REGISTRY OF RADIOACTIVE SEALED SOURCES AND DEVICES  
SAFETY EVALUATION OF DEVICE

NO.: NR-313-D-101-S

MODEL: ~~117 Laser Designator~~ AN/AAS-38A LASER DESIGNATOR

Subject: Registry Certificate No. NR-313-D-101-S

ATTACHMENT 3

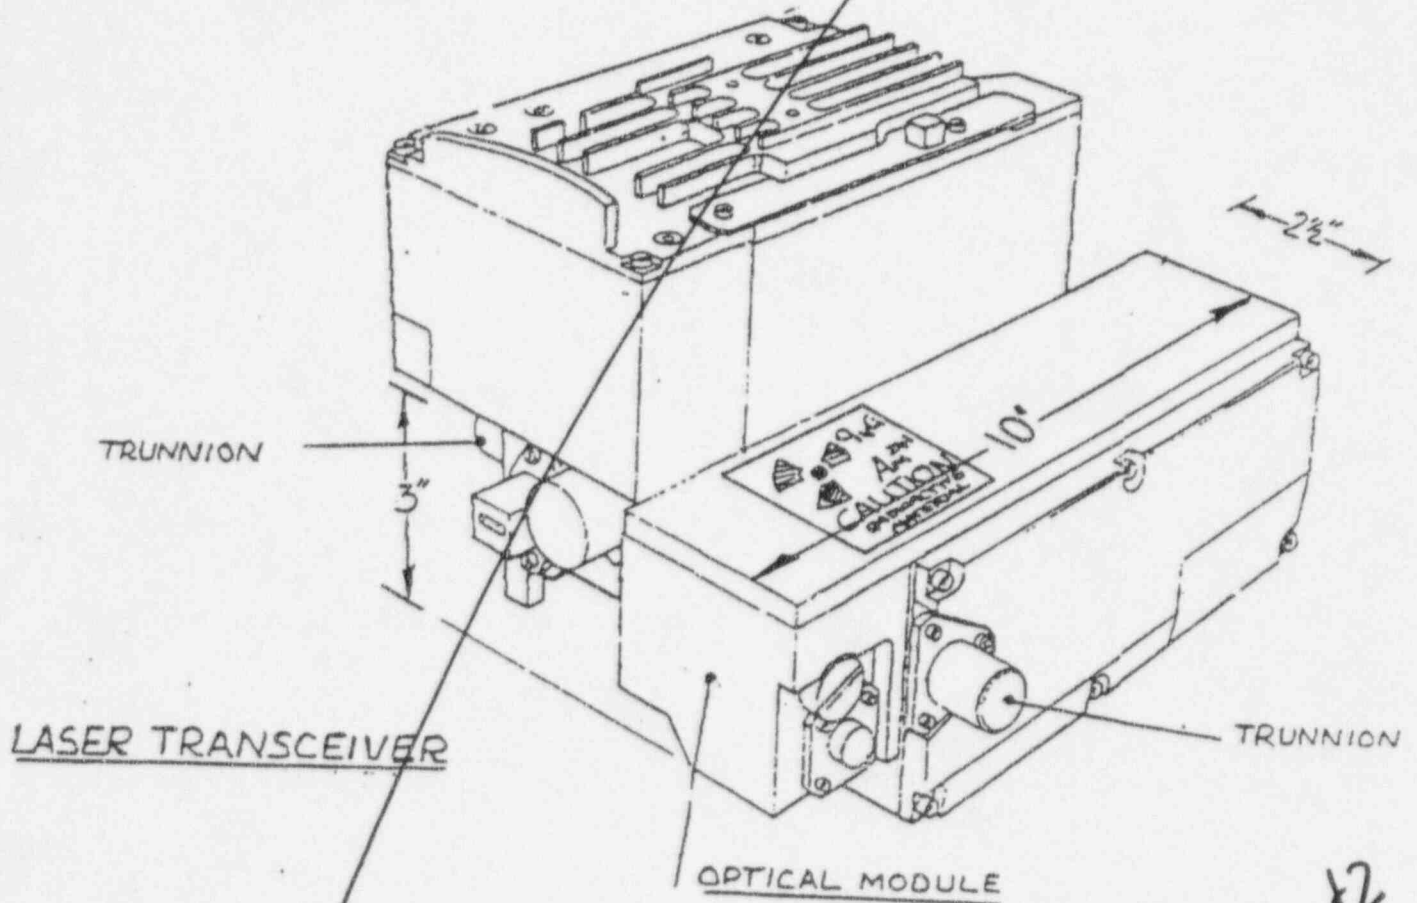
*Replace  
BY FIGURES 1 & 2*

Figure No. 1 Laser Transceiver (Top View)

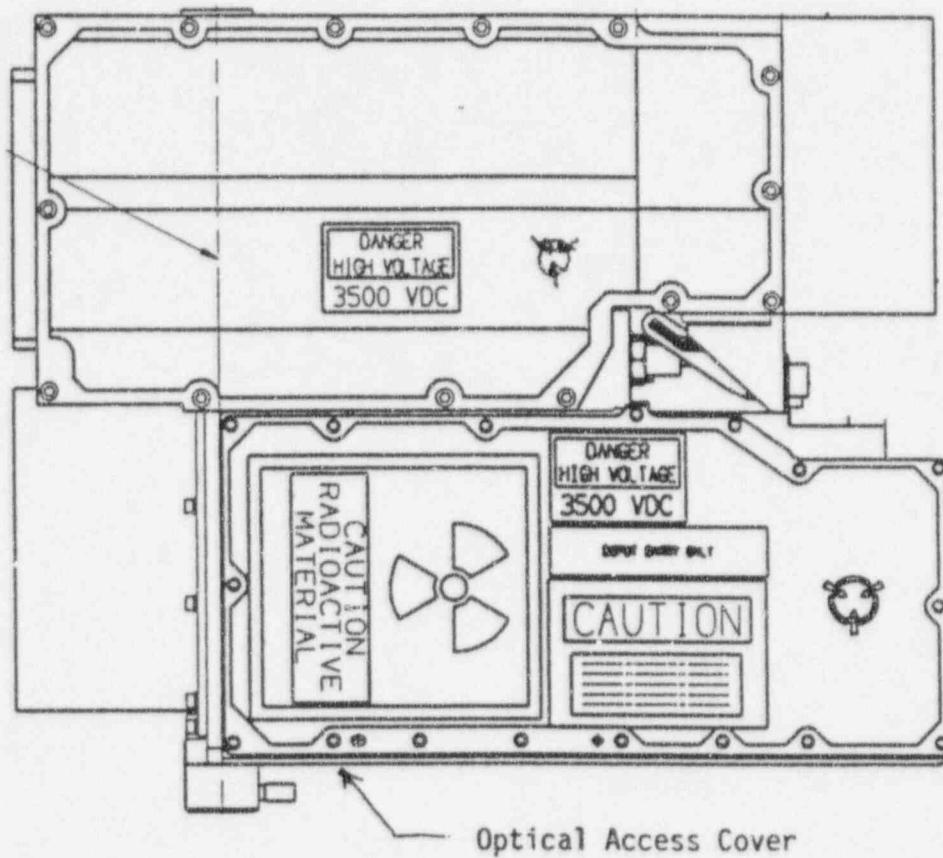
The device is contained in an environmental controlled cavity (AN/AAS-38A FLIR Pod). The device shown in Figure Nos. 1 and 2, contains two NRC-approved americium-241 (Am-241) sources (NR-136-S-~~174-1/2~~<sup>203</sup>), for the removal of static charge, one at each end of the laser's Q-Switch crystal permitting it to maintain its large characteristic discrimination ratio. The two sources are screwed and secured into the Optical Access Cover which is located on the laser transreceiver directly over the optics. The cover is an aircraft standard aluminum alloy machining, 7.5 inches long by 3.4 inches wide by 0.4 inches high, which mounts the sources. The optical elements of the laser are mounted within a sealed cavity directly below the cover. The cavity is approximately 1.7 inches deep and is also machined from aluminum. The sources are shown attached to the cover in Figure No. 5. The minimum thickness of the cover is .040 inches. The sources are placed approximately 1.5 inches apart and are threaded into the cover. An O-ring is placed between the chassis and cover. The cover is secured with seventeen screws and is opened only for depot maintenance. This prevents the ingress of moisture and the cavity is filled with dry nitrogen. Once assembled there is no ~~normal~~ access to the AM-241 sealed sources. 17?

Figure No. 5. Sealed Source Assembly

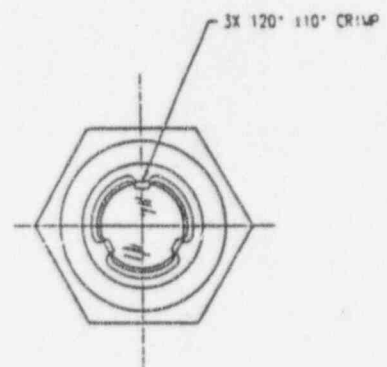
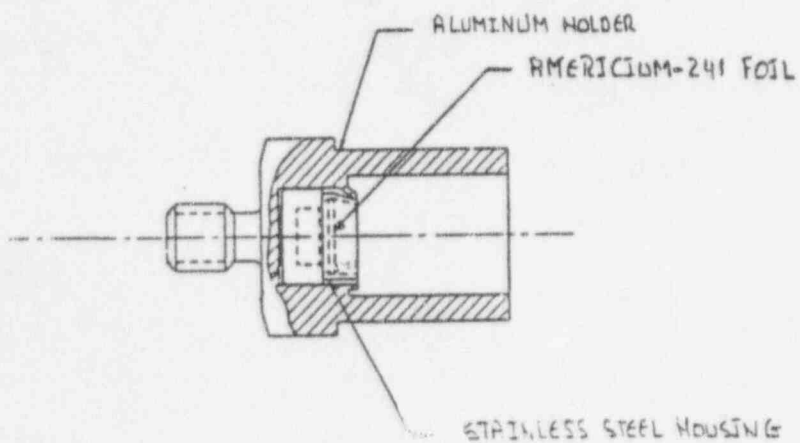
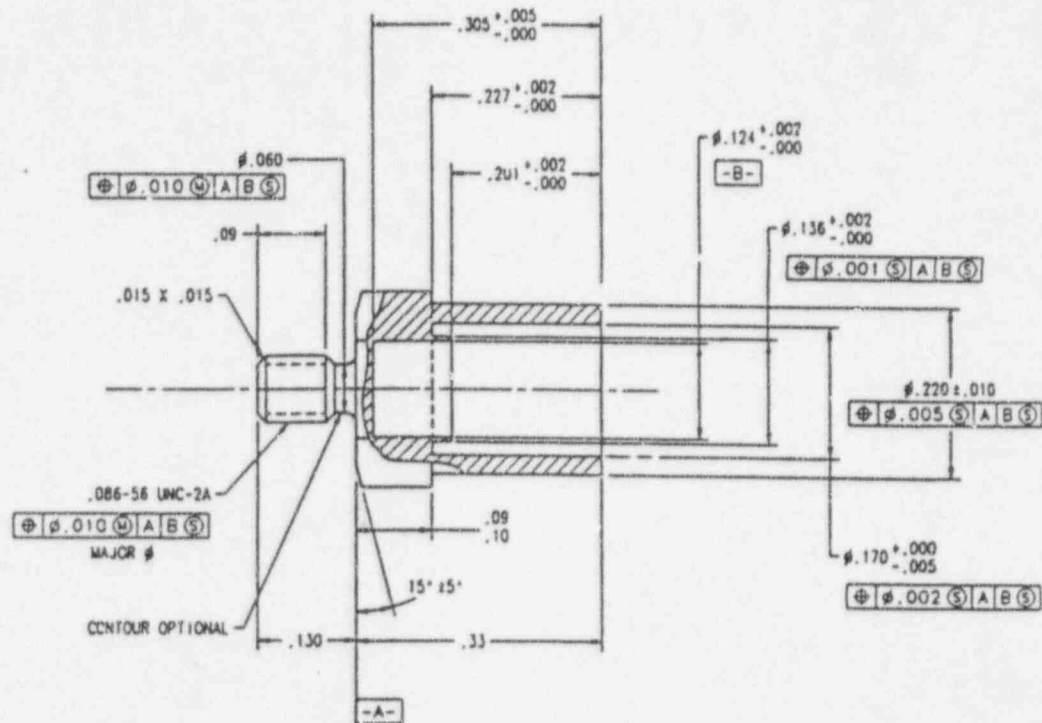
See new  
PAGE  
FIGURE NO
